Bureau of Land Management
PLAN AMENDMENT/FINAL EIS
FOR THE
GENESIS SOLAR ENERGY PROJECT

APPENDIX H

Comment Letters

COMMENTS
of the
CALIFORNIA UNIONS FOR RELIABLE ENERGY
on
Staff Assessment/Draft Environmental Impact Statement
Genesis Solar Energy Project
Application for Certification (09-AFC-8)

Exhibit 1: Conceptual Gen-tie Diagram

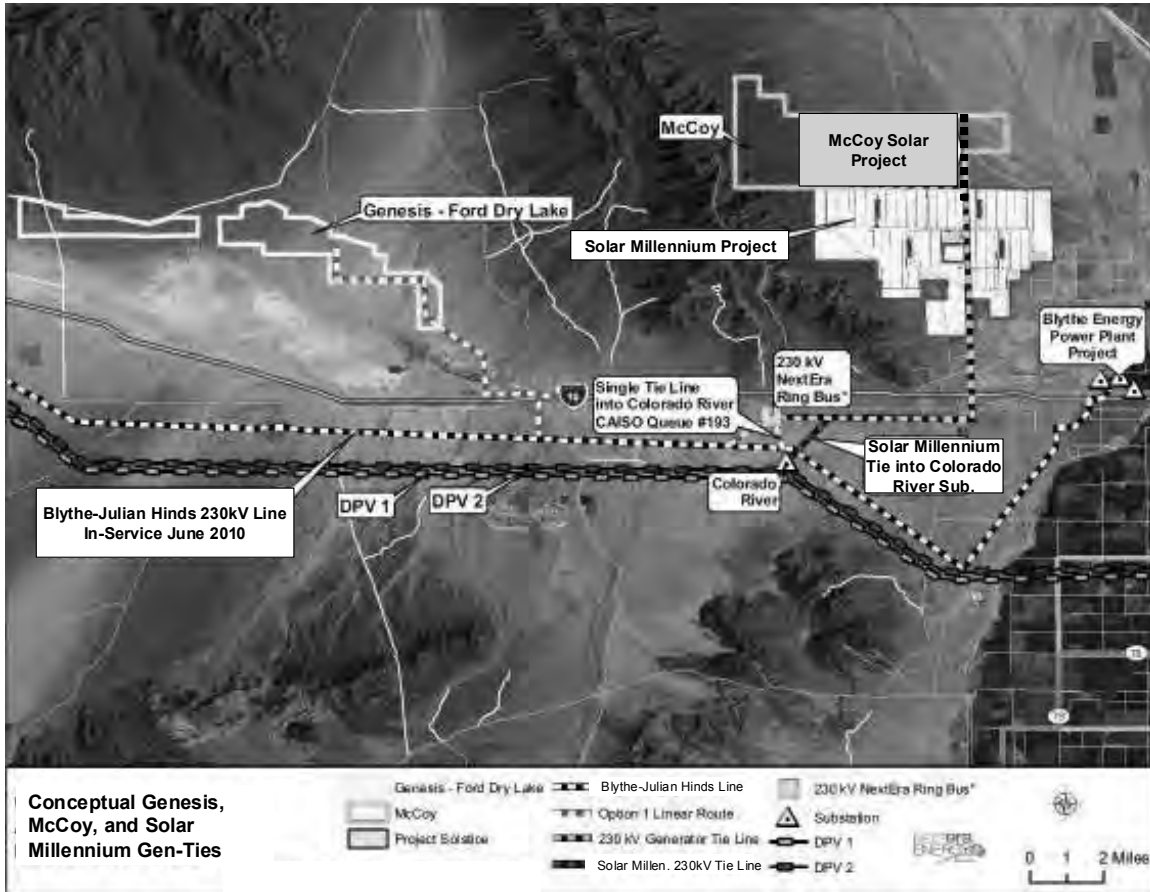
In order to minimize the environmental impacts associated with solar project development, NextEra Energy Resources, LLC (“NextEra”) and SolarReserve, LLC (“SolarReserve”) request that the Bureau of Land Management (“BLM”) and the California Energy Commission (“CEC”), give consideration to establishing a North-South utility corridor through the Solar Millennium Project site (the “Utility Corridor”) to accommodate an additional double circuit 230kV line which would run in parallel to the Solar Millennium’s planned double circuit 230kV gen-tie to the SCE Colorado River Substation (reference attached conceptual drawings, Exhibits 1 & 2).

This Utility Corridor and additional double circuit 230kV line would allow projects to the north of the Solar Millennium Project to access Colorado River Substation with less environmental and land use impacts than alternatives which would involve creating additional, separate transmission line corridors around Solar Millennium’s Project either to the west or to the east. NextEra would also provide a similar transmission right-of-way access along the eastern boundary of McCoy as shown in Exhibit 1, attached. By establishing the Utility Corridor, linear facilities from projects to the north would be combined and minimized, consistent with BLM and CEC best practices guidance for desert renewable energy projects.
